**PROJECT SPECIFIC PLAN FOR
AREA 9, PHASE III OUTFALL DITCH
PREDESIGN INVESTIGATION
(SUPPLEMENT TO 20300-PSP-0011)**

**FERNALD CLOSURE PROJECT
FERNALD, OHIO**

**21140-PSP-0002
Revision 1
FINAL**

APPENDIX C**AREA 9, PHASE III PREDESIGN VARIANCES**

FIGURE 2.

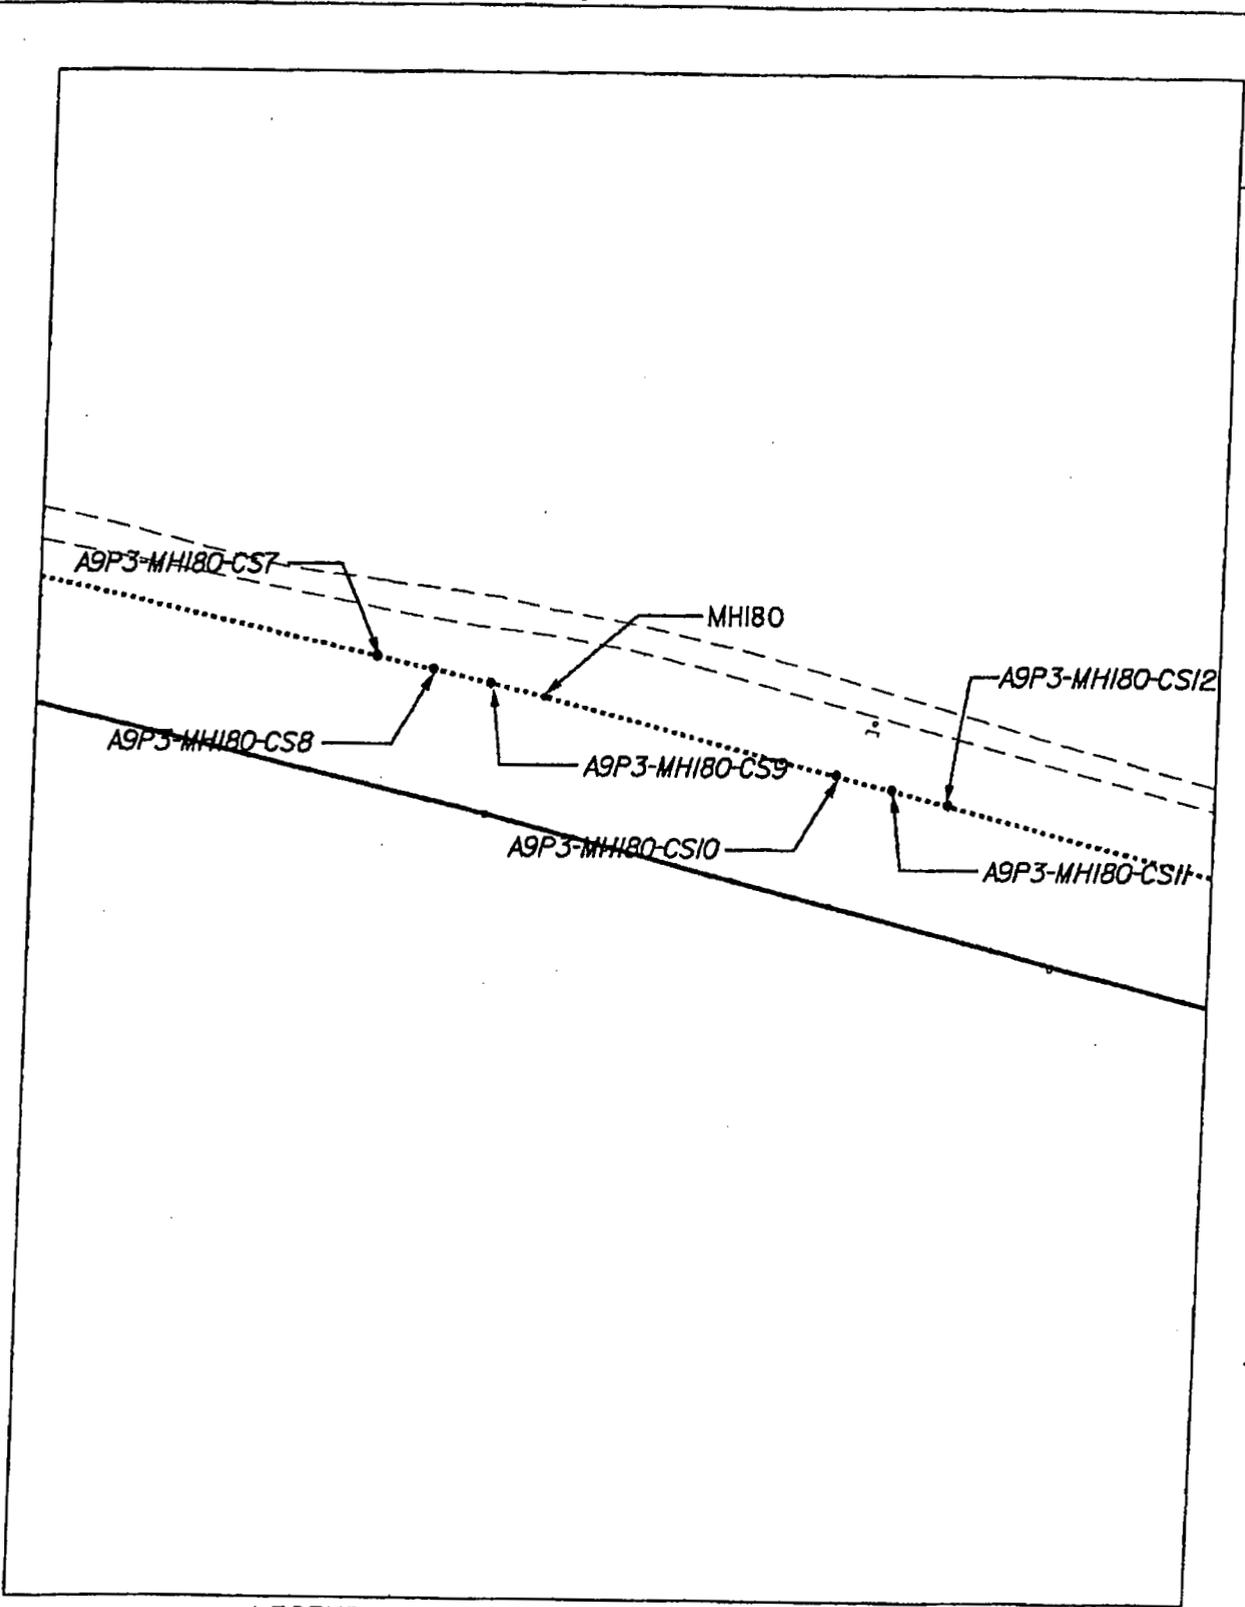
- Three of the locations will be field located by the field sampling lead and are to the east of MH178 along the southern fence line in the previously plowed area. There should be approximately 50 feet between each location. See Figure 1.
- Three locations (to be surveyed in) are to the west of MH180 and should have approximately 25 feet between locations. The first western location should be placed approximately 25 feet to the west of MH180 with the second and third continuing west. See Figure 2.
- The final three locations (to be surveyed in) are to the east of MH180. The first location should be placed approximately 125 feet to the east of MH180 and there should be 25 feet between each location. See Figure 2.

FIGURE 1. V/FCN 21140-PSP-0002-12

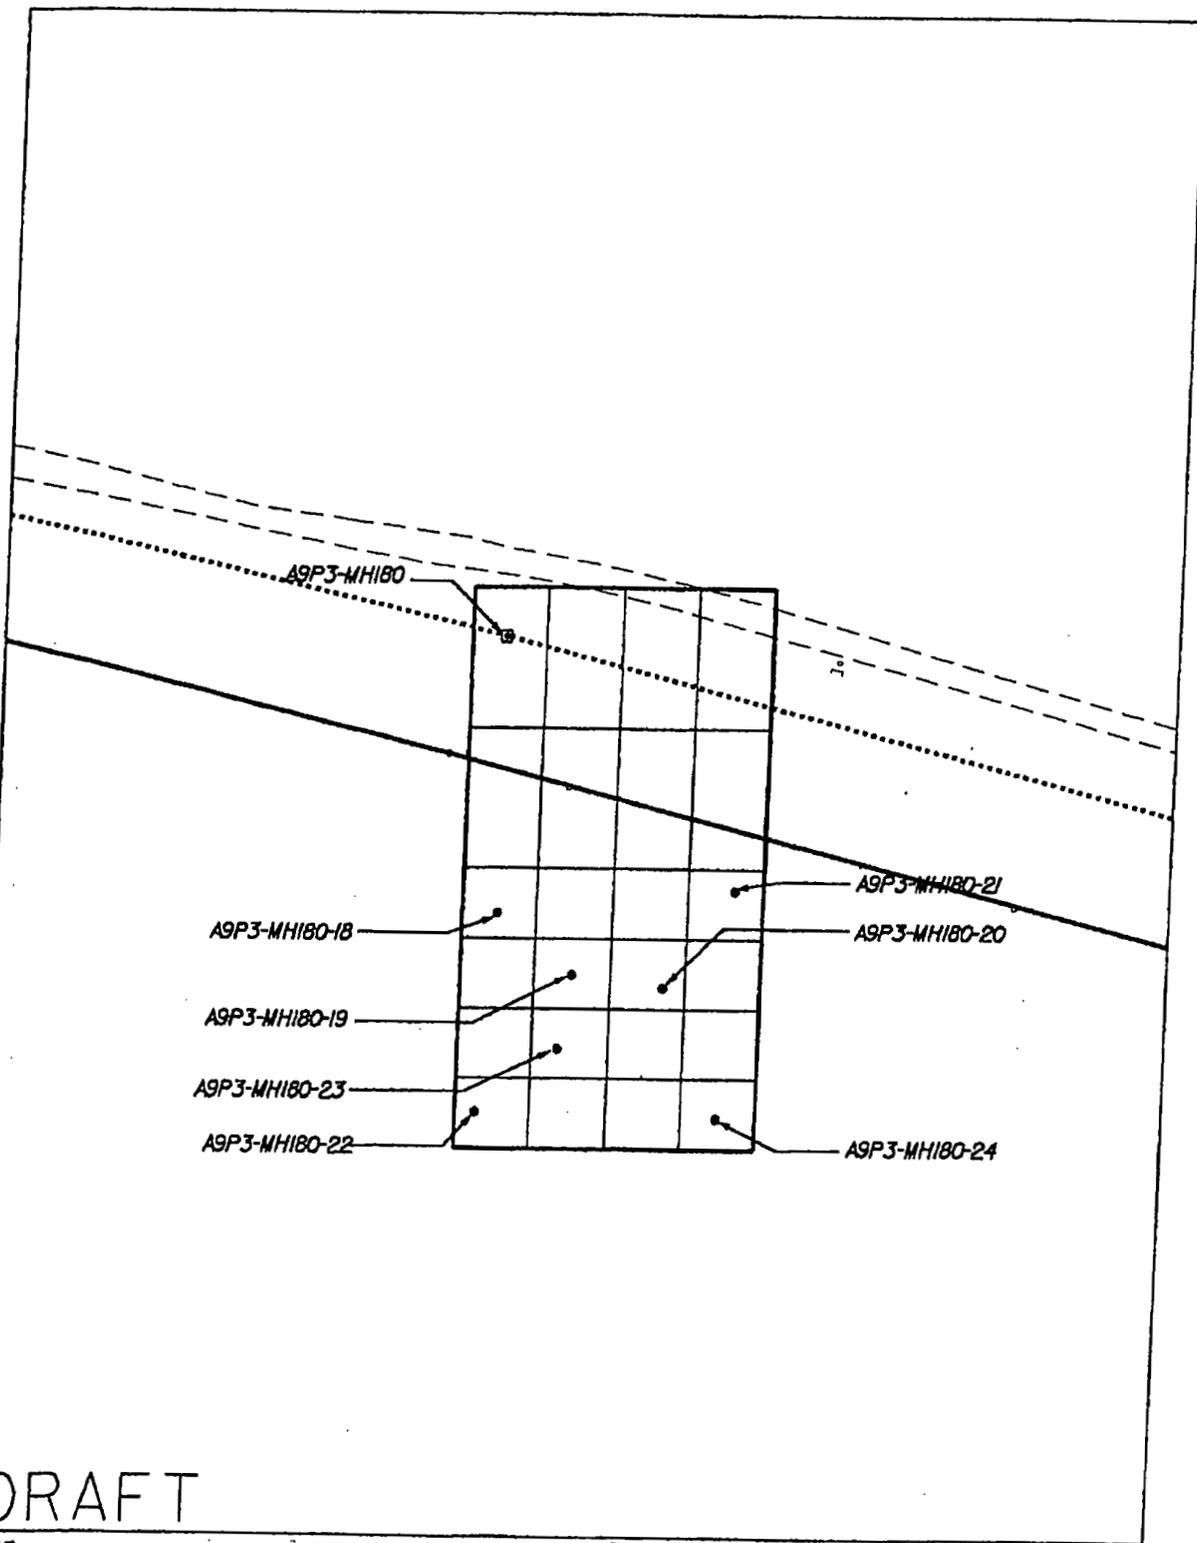
This Variance/Field Change Notice (V/FCN) documents the collection of composite samples from seven additional locations south of MH 180.
